My responses to this, Document Reference: EX2/GH8.1.15

RESPONSE TO APPLICANT'S RESPONSES TO WRITTEN REPRESENTATIONS AT DEADLINE 1 : HYD-003 – LAVENDON

Figure 4-5: Lavendon - Recorded Rainfall Radar Depth Plot

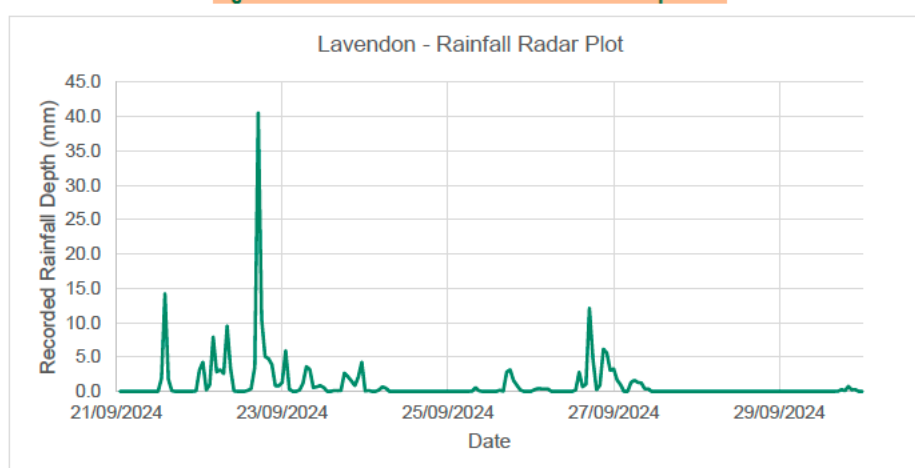
Table 4-2 shows the largest observed 144-hour (6-day) total (cumulative 60 min rainfall data) was 222 mm and was recorded in Lavendon. Maximum rainfall depths were high across all hotspots, most notably in Lavendon, Bradwell and Bletchley.

With reference to the latest Section 19 Report, the occurrence of a 1 in 1,000 AEP event has already taken place based on rainfall records referenced in the report.

CDC2: Lavendon

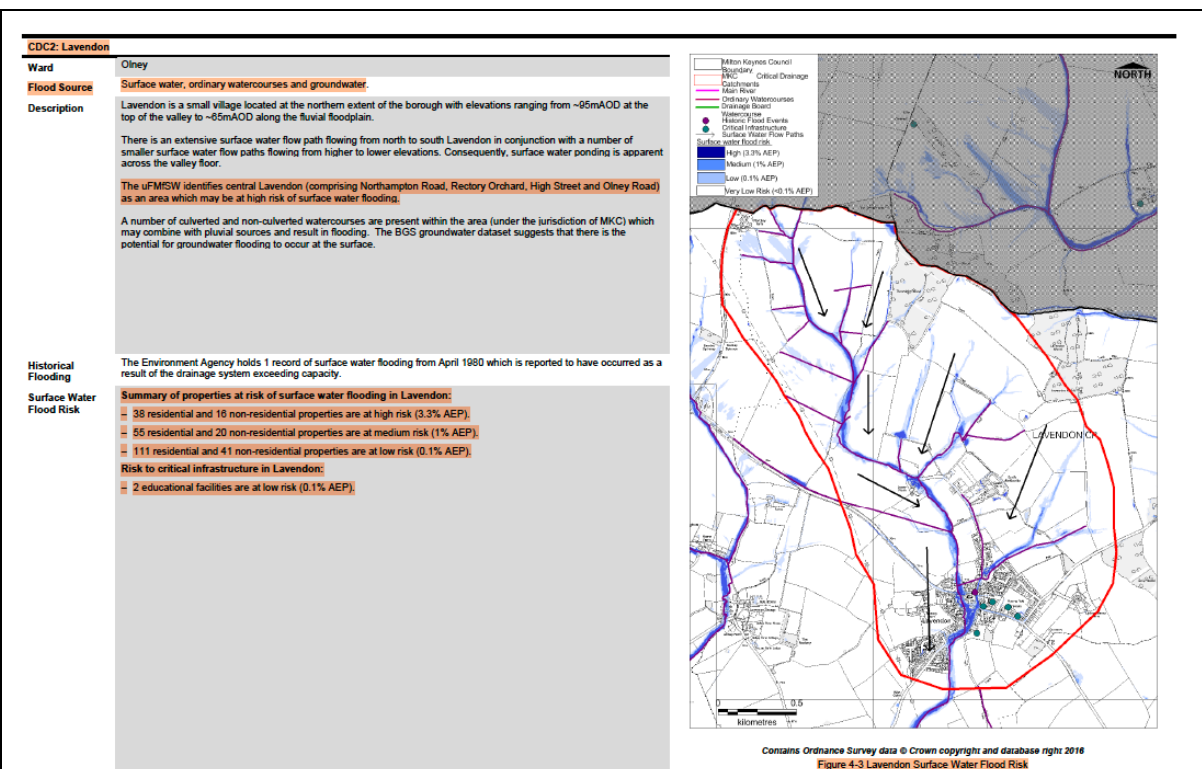
The developer's attention is drawn to the Surface Water Flood Risk comments as well as the surface water flow paths. **Three of the surface water flow paths run through sites G-9 and G-13.**

7. The developer appears to have omitted key information from the Milton Keynes Surface Water Management Plan (Final Report April 2016). This plan contains the surface water flow paths in Lavendon - three of the surface water flow paths run through sites G-9 and G-13.

Location F

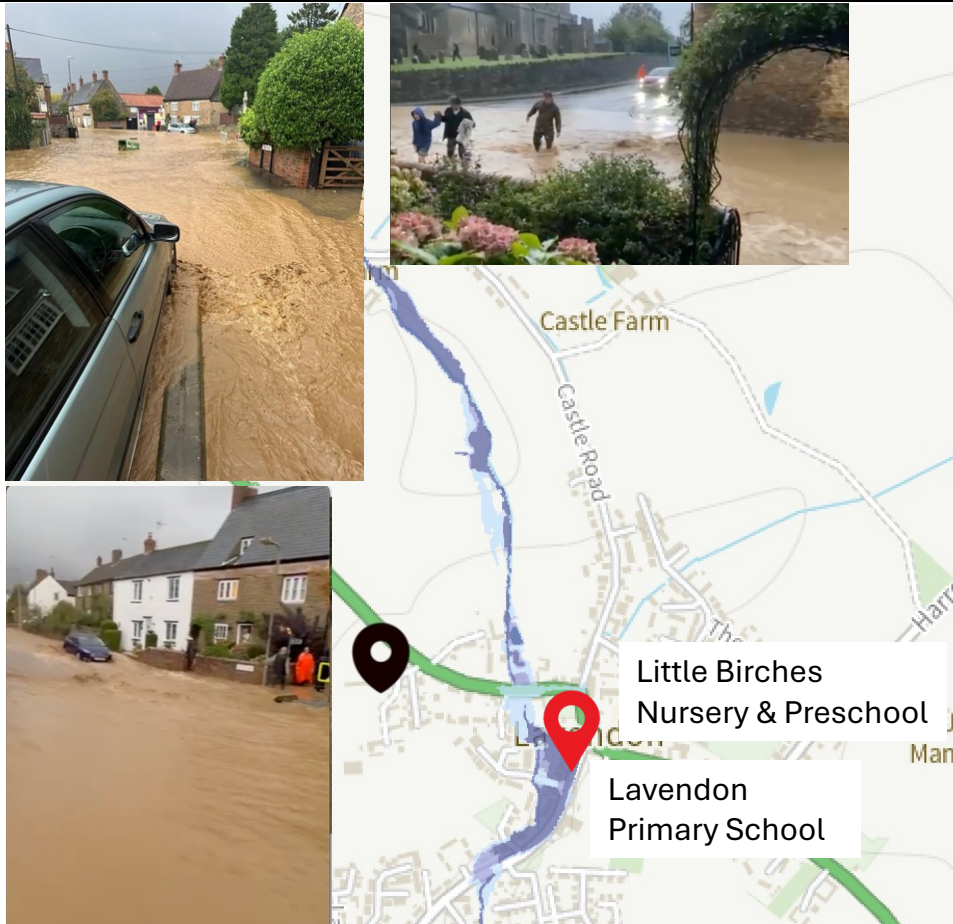
The developer, in accordance the documents referenced as part of their own design and FRA, should read the notes from the Environment Agency (EA) and Lead Local Flood Authorities (LLFAs) and Flood Estimation Handbook (FEH) and include these as Historic Flood Events to recalibrate their hydraulic models.

With specific reference to the following verified photos taken from the most recent floods, I sincerely hope that the developer is fully aware that the lack of incredibly detailed, careful and extremely comprehensive FRA based on their own admissions of flood zoning and failure to adhere to MK policy could in reality lead to danger to life and limb, especially in a flood-flash scenario. I would trust that this on its own would cast a different light on their approach to the proposed development.

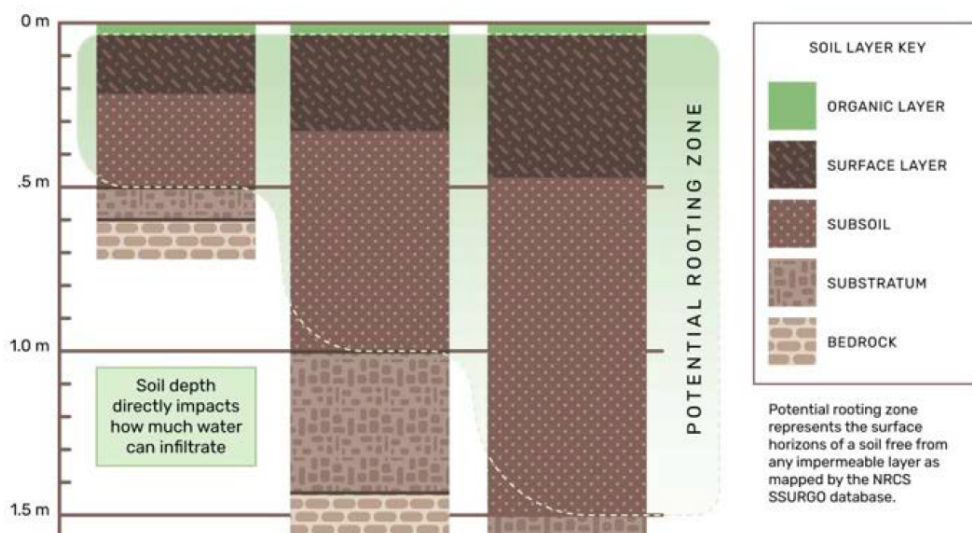
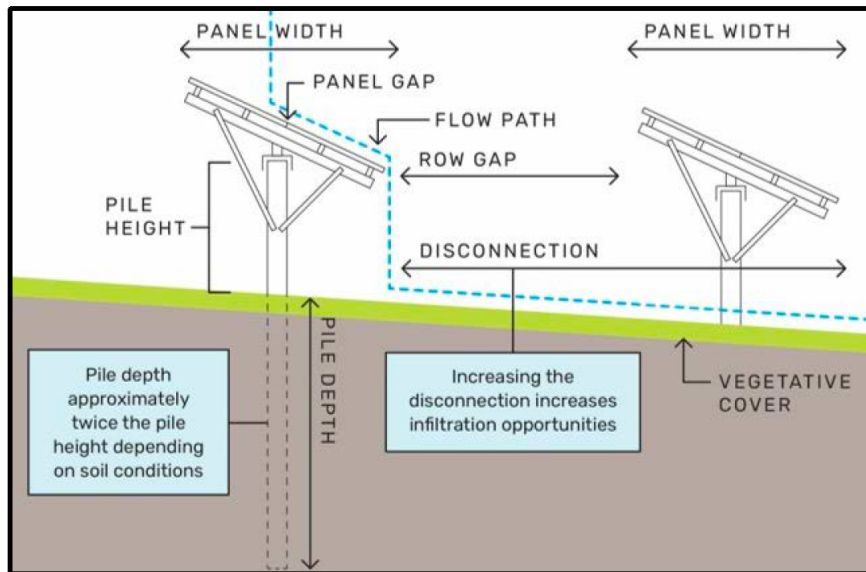
1. **Compaction**—managing soil compaction and bulk density across the site. **Runoff increases on average by 98% with compacted vs. loose soil in full sun areas**

2. **Soil depth**—including soil depth (rooting depth) in stormwater modeling and design. **Runoff increases on average by 78% as soil depth decreases from 150 cm to 50 cm.**

Please could the developer comment on the findings of this research, particularly the findings concerning soil depth.

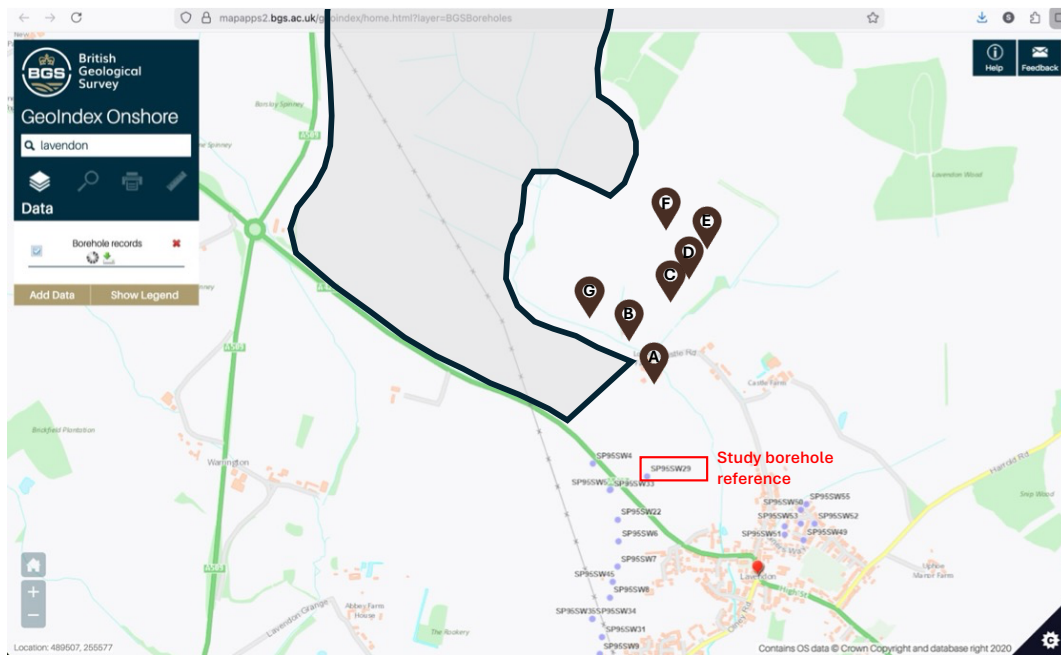
In APP-107 Clause 1.6.1 the geology refers to the British Geological Survey (BGS) online mapping (1:50,000 scale) which indicates that the Site is underlain by superficial deposits of Oadby Member generally comprising Diamicton. The superficial deposits are identified as being underlain by Cornbrash Formation consisting of Limestone.

In Clause 1.6.2 it is stated that the geological mapping is available at a scale of 1:50,000 and as such may not be accurate on a Site-specific basis.

The respondents took the time to physically visit the site and dig coordinated trial holes at more relevant points to the development. Trial holes were excavated until hard limestone was found. The plan/location of these trial holes compared to the quoted borehole reference is:
